Annex O

Micklegate Ward

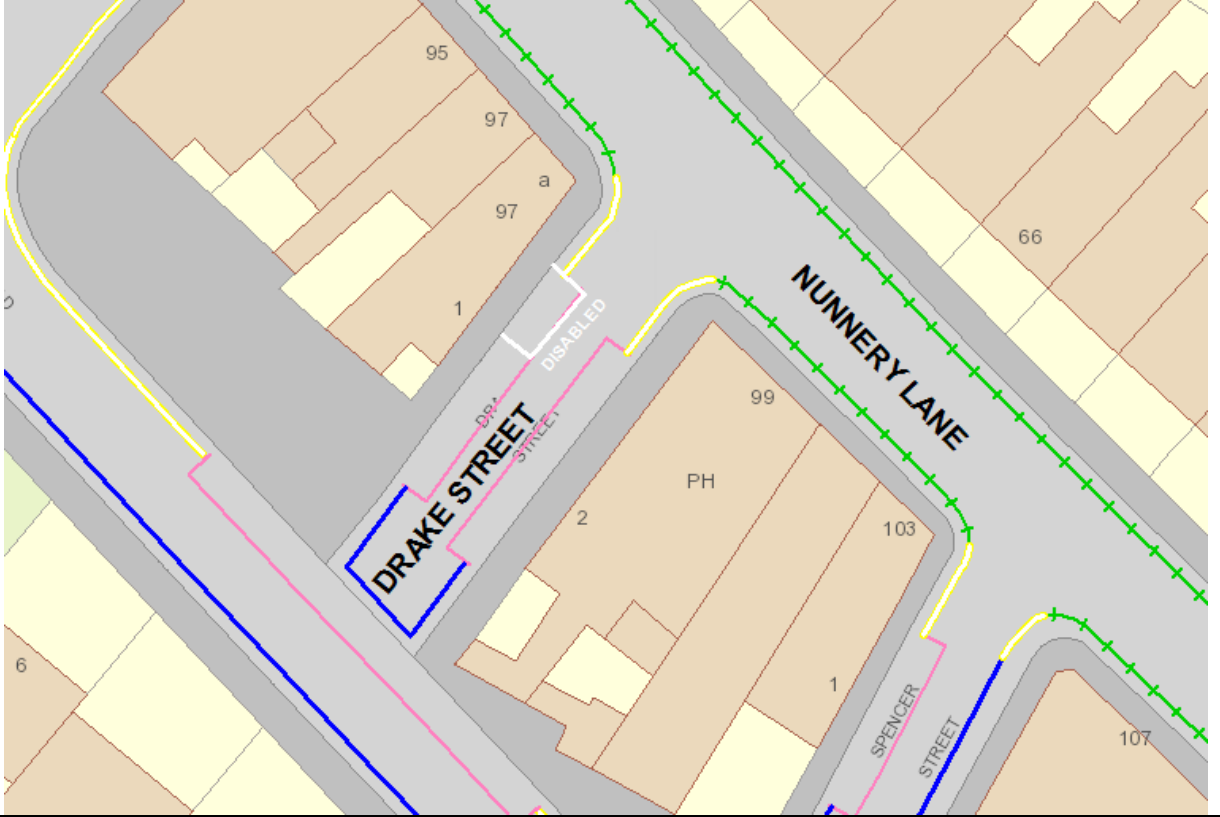
O1	Location: Drake Street
Nature of problem and requested solution The resident who applied for the disabled bay has requested we make the bay enforceable as it is frequently being used by non-blue badge holders.	
Background information The resident lives on Nunnery Lane and the bay is located on Drake Street.

Recommendation To add the bay to the Traffic Regulation Order so it can be enforced when used by non-blue badge holders.	
Cost: Lining works: n/a Advertising + Making: £500.00 Total: £500.00

Location: Campleshon Road

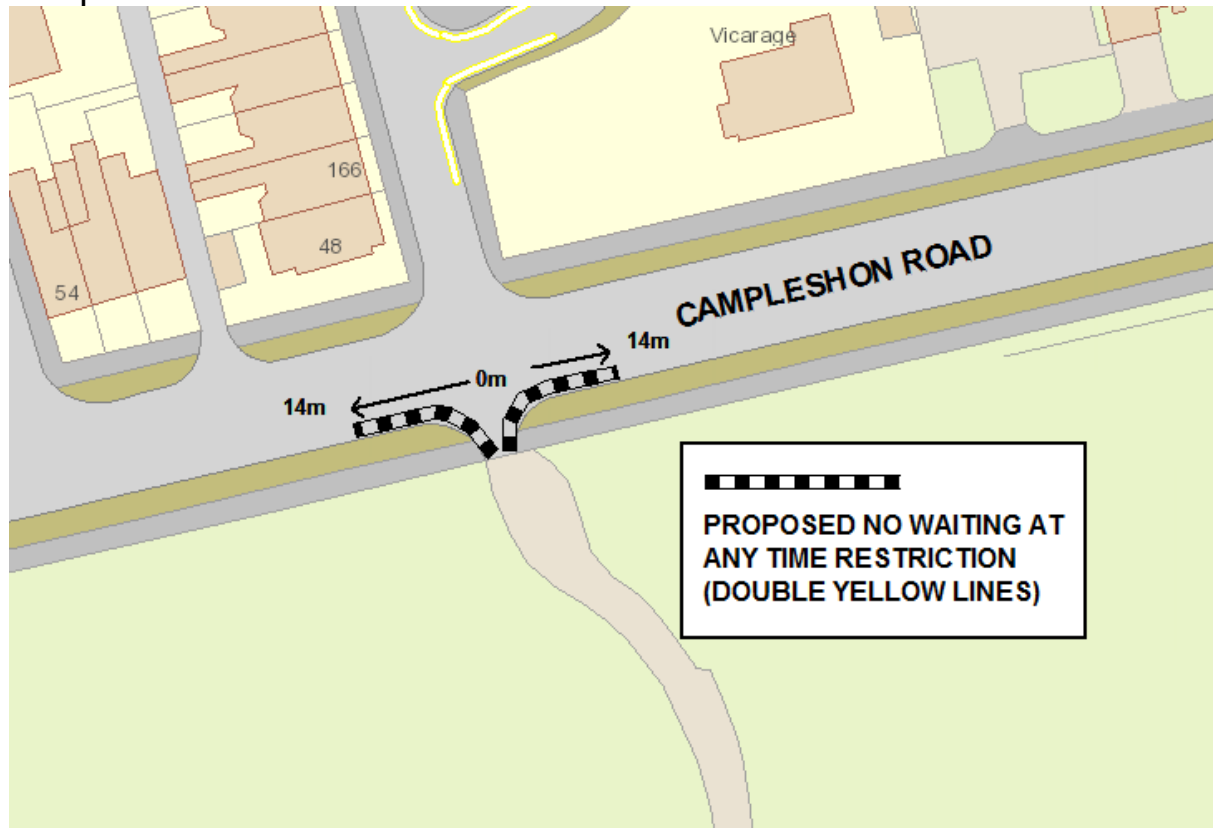
Racetech Events have raised an issue regarding vehicles parking close to the exit of car park D and causing an obstruction to their vehicles being able to exit the compound the vehicles are stored in during race days.

To implement no waiting at any time restrictions either side of the compound exit.

Location: Sutherland Street/ Count De Burgh Terrace

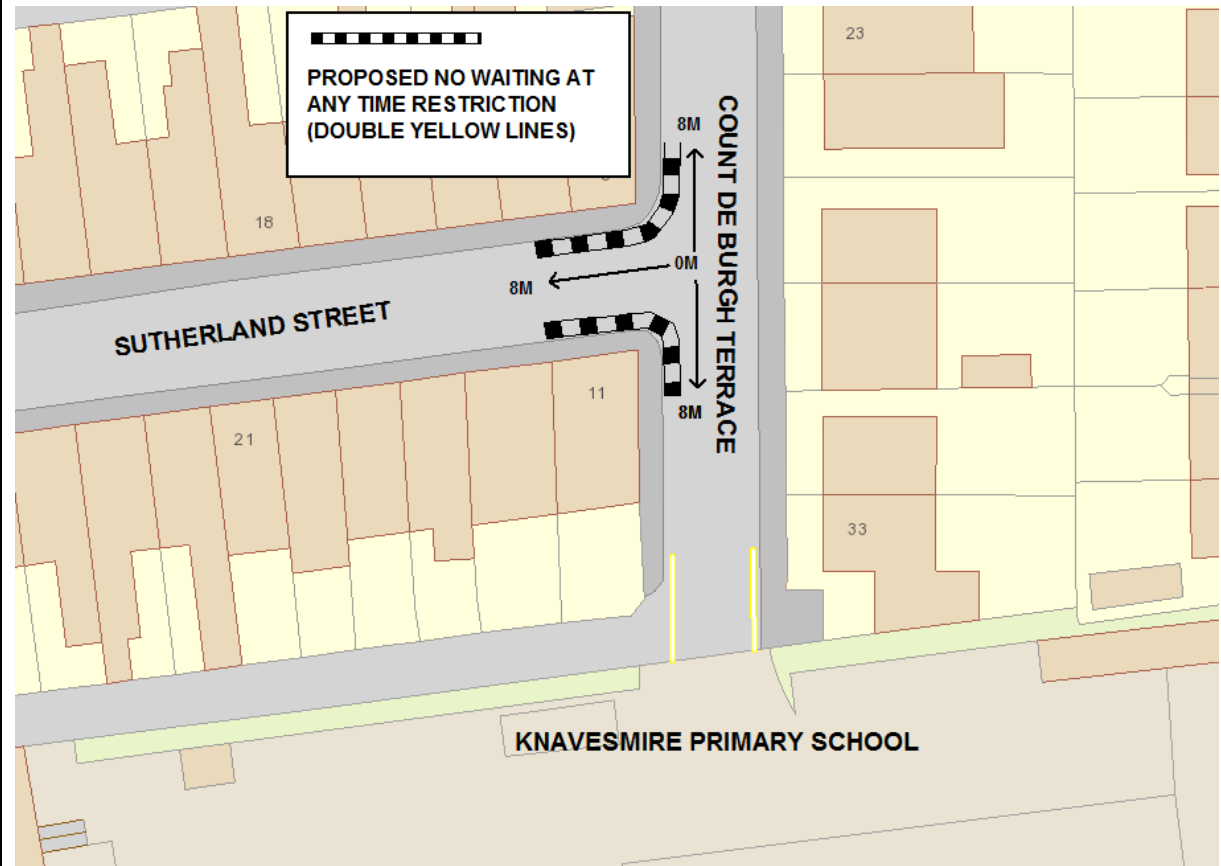
A resident has requested a review of the junction of Sutherland Street and Count de Burgh terrace due to vehicles very close to the junction restricting visibility and access to the street.

To implement no waiting at any time restrictions 8m in each direction. Three site visits witnessed vehicles parking very close to the junction and access was restricted.

Location: Clementhorpe

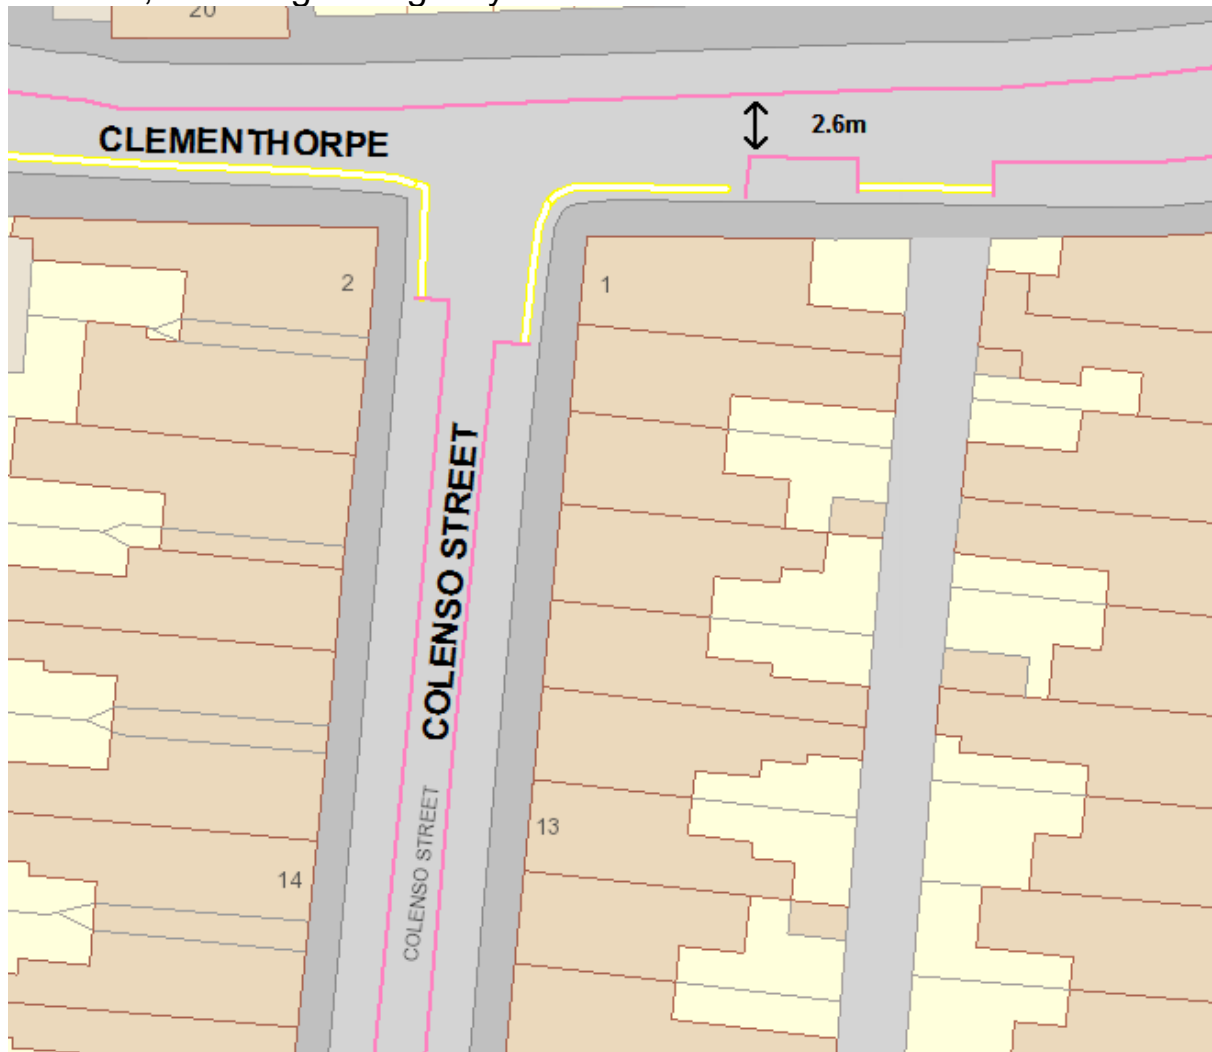
Residents have raised the issue that large vehicles are unable to proceed along Clementhorpe when vehicles are parked in one of the Respark bays on Clementhorpe.

Revoke the bay and replace with no waiting at any time restriction. the distance between the bays is 2.6m which is not wide enough for larger vehicles, including emergency vehicles.

Location: Nunthorpe Road

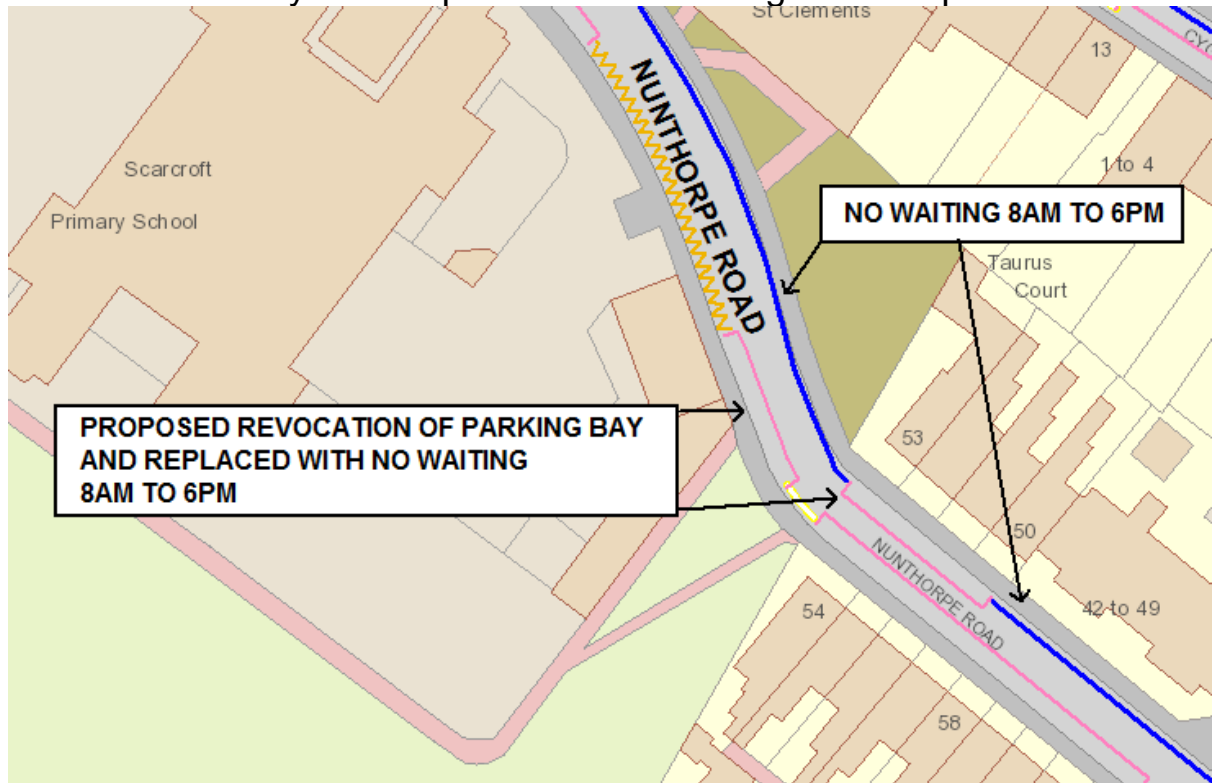
The Waste Services team have requested the revocation of two parking bays on Nunthorpe Road due to parked vehicles preventing access to complete the refuse collection. Refuse wagons have been unable to complete collections on numerous occasions and have also been unable to leave the area when vehicles have parked after the wagons have entered the area.

To revoke the bays and replace with no waiting 8am to 6pm.
